Subject: **Response to NRC RAI Letter No. 363 Related to ESBWR Design Certification Application – DCD Tier 2 Section 3.8 – Seismic Category I Structures; RAI Number 3.8-94 S05**

**Response to NRC RAI Letter No. 363
Related to ESBWR Design Certification Application¹**

DCD Tier 2 Section 3.8 – Seismic Category I Structures

RAI Number 3.8-94 S05

Figure 3.8-94(1) Input Motion Spectra and RFB SSI Fundamental Frequencies

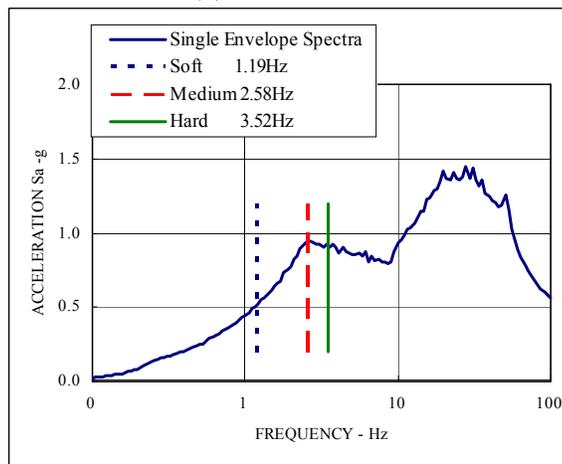
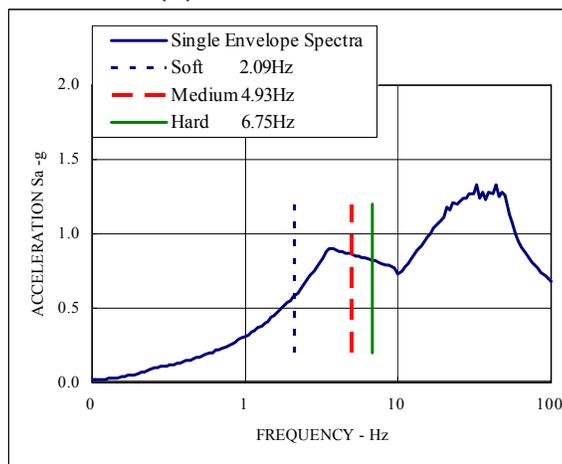
- (2) GEH is requested to explain why it is acceptable to use a linearly interpolated value for the soil bearing capacities between the three sets of values (soft, medium, and hard). Using the information presented in Figure 3.8-94(1) (c) of the response (as an example), this would underpredict the required bearing capacity.*

In accordance with NRC RAI 3.8-94, Supplement 2, Figure 3.8-94(1) (c), the vertical input response spectrum peaks at 3.57 Hz in the frequency range between 2.09 Hz for the soft site and 4.93 Hz for the medium site. This peak vertical frequency is 73% of the vertical SSI fundamental frequency at the medium site.

Applying the same frequency ratio to the horizontal SSI frequencies of the medium site, the horizontal SSI fundamental frequencies for the 3.57 Hz vertical frequency site (termed "intermediate site" hereafter) are found to be 2.14 Hz and 1.87 Hz in the NS and EW directions, respectively. The corresponding spectral accelerations are 0.85g, 0.76g and 0.9g in the NS, EW and vertical directions, respectively, and the corresponding ratios to the medium site spectral accelerations are 0.91, 0.8 and 1.05, as shown in Figure 3.8-94(2).

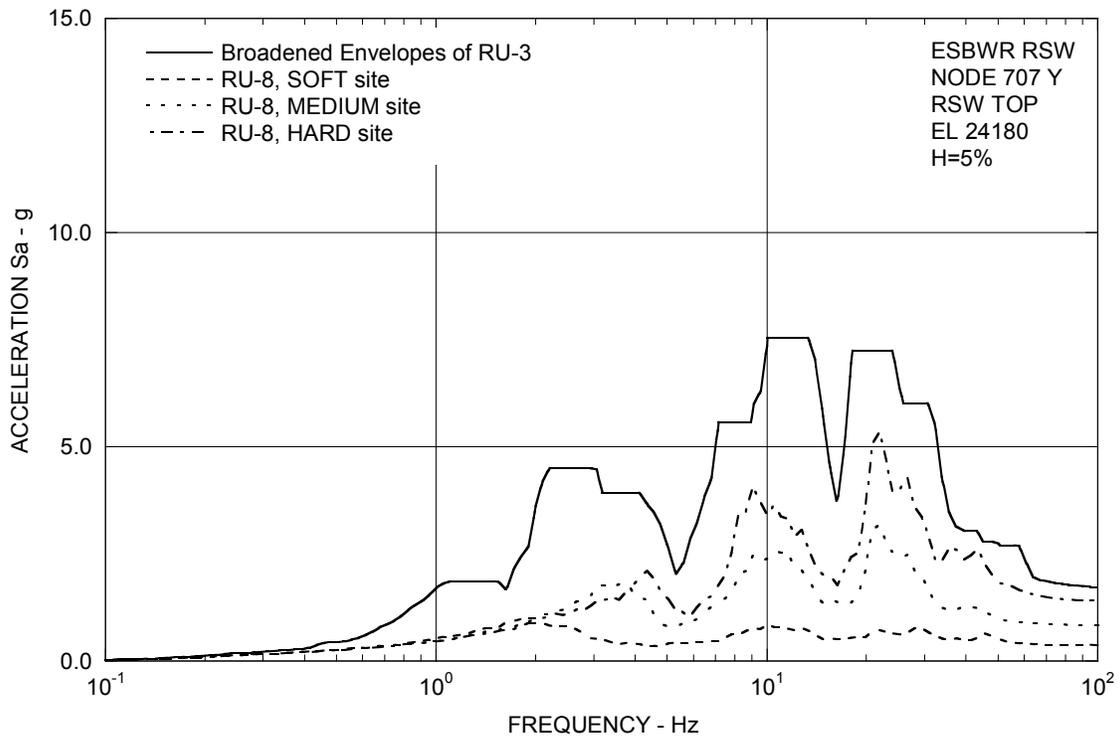
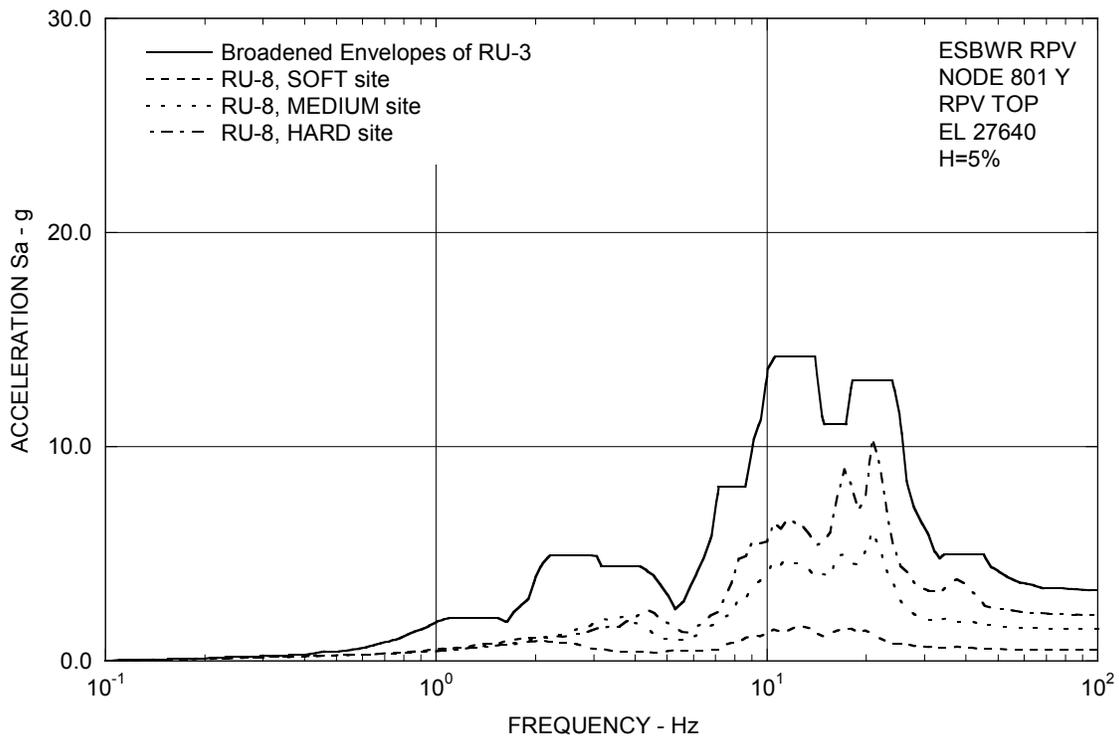
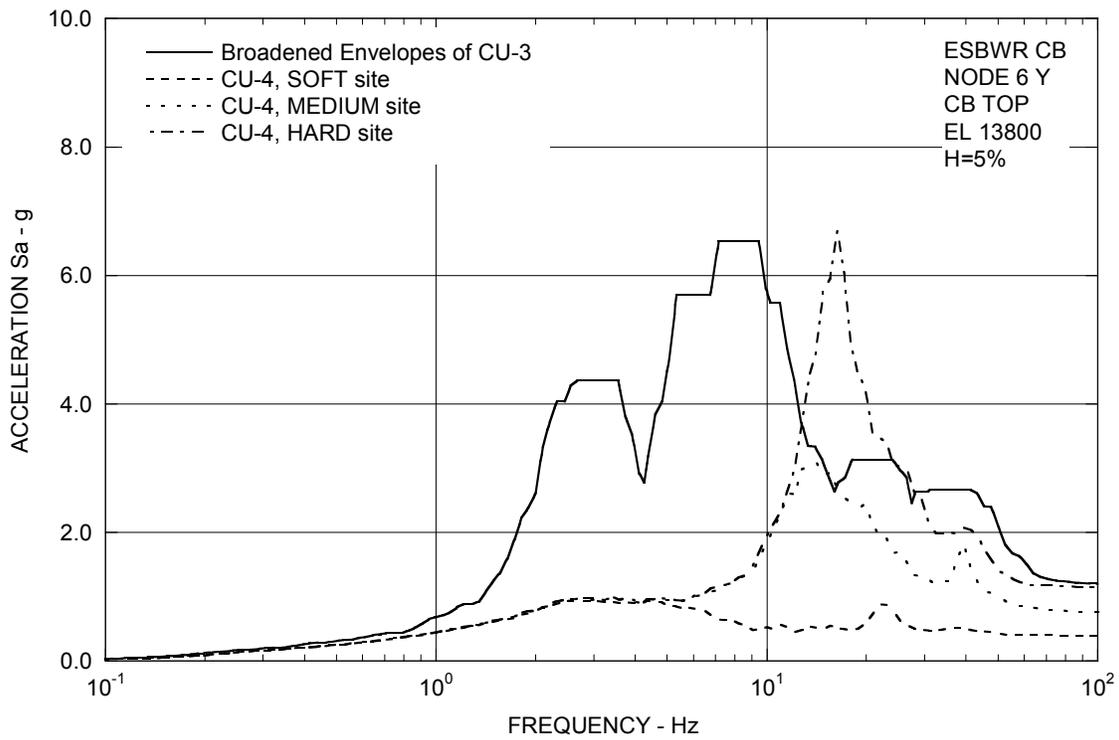
- I) *In several of the enveloping floor response spectra (e.g., Figures 3.8-94(19), (20), and (22), the staff noted that “valleys” exist between successive peaks in the low frequency region, up to approximately 5 Hz. If the spectral peaks are influenced by site conditions, it is the staff’s position that these “valleys” should be filled-in to accommodate the expected variability in site shear wave profiles that may be encountered for this generic design. GEH is requested to provide an explanation why these valleys have not been filled-in.*

- I) Sufficient levels of conservatism are already built into the design floor response spectra in the form of enveloping and peak broadening the results of a sufficient number of generic sites under a bounding Certified Seismic Design Response Spectra (CSDRS) ground input motion. To provide additional margins for sites that might have predominant SSI frequencies at the spectral valleys, the spectral valleys of the site enveloping floor response spectra are further filled-in for the generic design floor response spectra. As an example, the original enveloping floor response spectra at the Vent Wall top, which is the same location as shown in Figure 3.8-94(18), is shown in Figure 3.8-94(43) together with its respective enveloping floor response spectra having the spectral valleys filled-in. The site enveloping floor response spectra in DCD Tier 2 Subsection 3A.9.2 will be replaced in Revision 6 with enveloping floor response spectra having the spectral valleys filled-in. DCD Tier 2 Subsections 3A.8.7 and 3A.9.2 will be revised in Revision 6 for clarification with regards to the spectral valleys being filled-in.

Figure 3.8-94(40) RB/FB Layered Site Soil Case RL-2, Time = 7.810 sec

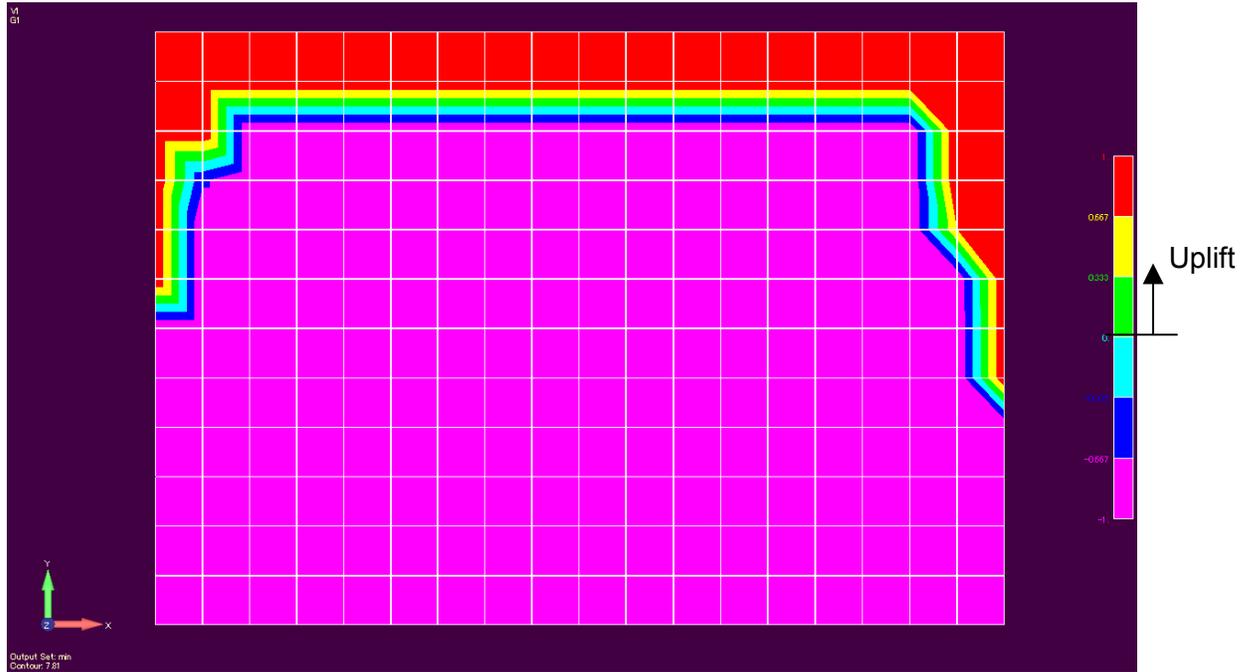
Lastly, provide the magnitude of the uplift calculated using the EBM so that a comparison can be made with the extent of implied uplift (i.e., tensile basemat/soil interface loads) shown in Figure 3.8-94(40) of the RAI response. The above requested

The SASSI results for the RB/FB layered site soil Case RL-2 are examined for the extent of maximum uplift when the bearing pressure reaches maximum in combination with dead loads and buoyancy. As shown in Figure 3.8-94(40), the extent of uplift is not extensive and a large portion of the basemat remains in contact with the soil.

Figure 3.8-94(44) Basemat Configuration and Pressure Distribution

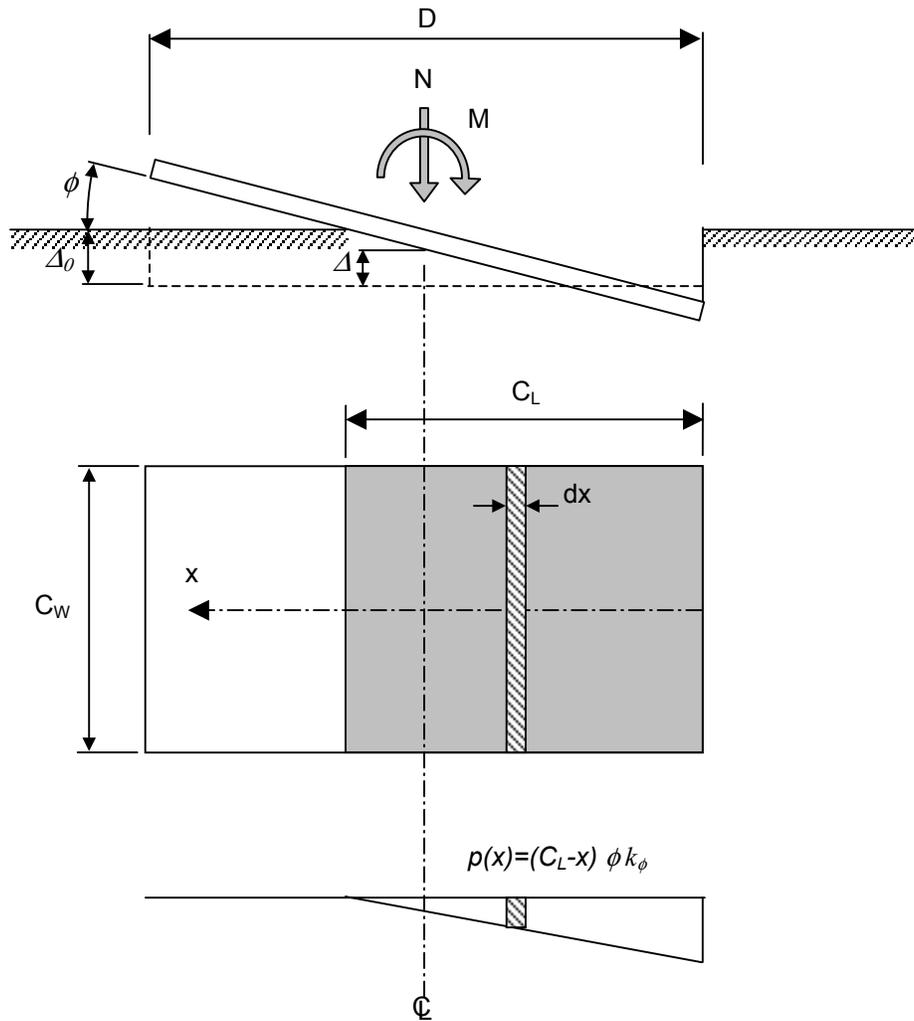
- 1. The formulation presented in the referenced paper is applicable to circular rigid foundations. Provide justification for use of these formulations for the rectangular foundations for ESBWR. Otherwise, if a new set of formulations were derived for the rectangular foundations at ESBWR, provide the basis for these new formulations.*

Figure 3.8-94(44) shows the configuration of a rigid rectangular basemat in the uplifted position. The basemat is considered to be supported by a set of uniformly distributed compression (no tension) vertical soil springs having stiffness k_ϕ per unit area, which are determined by the following:

Referring to Figure 3.8-94(44), the foundation vertical force N and the overturning moment M in the uplifted position can be related to soil pressure $p(x)$ and the foundation contact length C_L .

Figure 3.8-94(46) Soil Pressures due to Moments in Two Directions

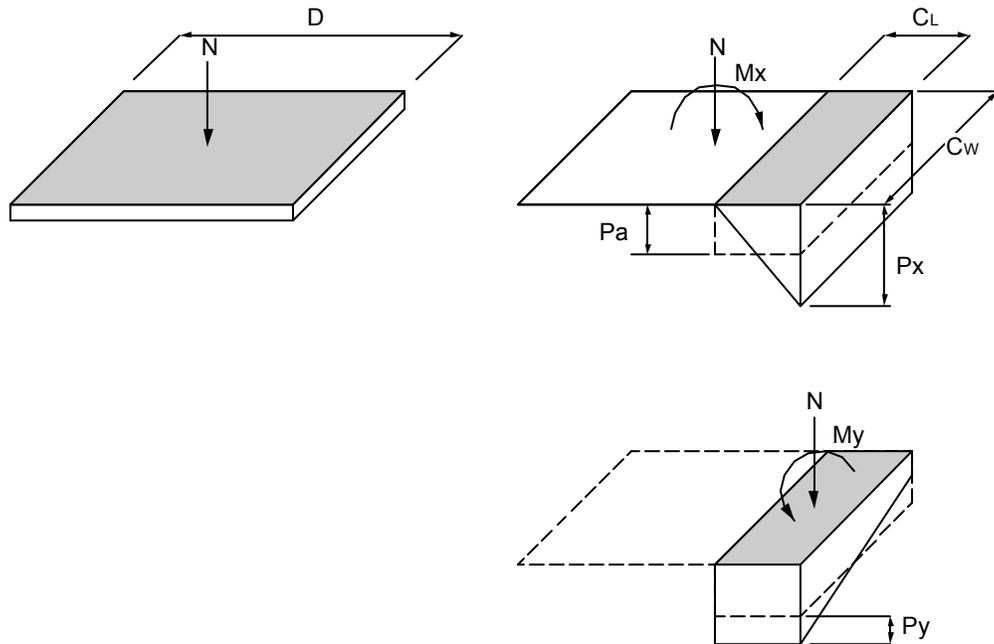
- 3. Confirm that the "Contact Width – CW" used in the formulations for bending about the other (perpendicular) horizontal axis corresponds to the full width of the foundation. If this is the case, then explain why the full width is utilized. Has it been determined that no uplift is possible for rotation about the other horizontal axis or that the uplift about both axes do not occur at the same time? The staff notes that if there is uplift possible for rotation about the other horizontal axis, this might cause higher soil bearing pressures than those calculated in the RAI response.*

- (3) To account for potential uplift due to rotation about the other horizontal axis, two separate cases, a) M_x using MEB together with M_y with full width C_W and b) M_y using MEB together with M_x with full width C_W , were considered as illustrated Figure 3.8-94(46). The final soil bearing pressure is the envelope results of the two cases.
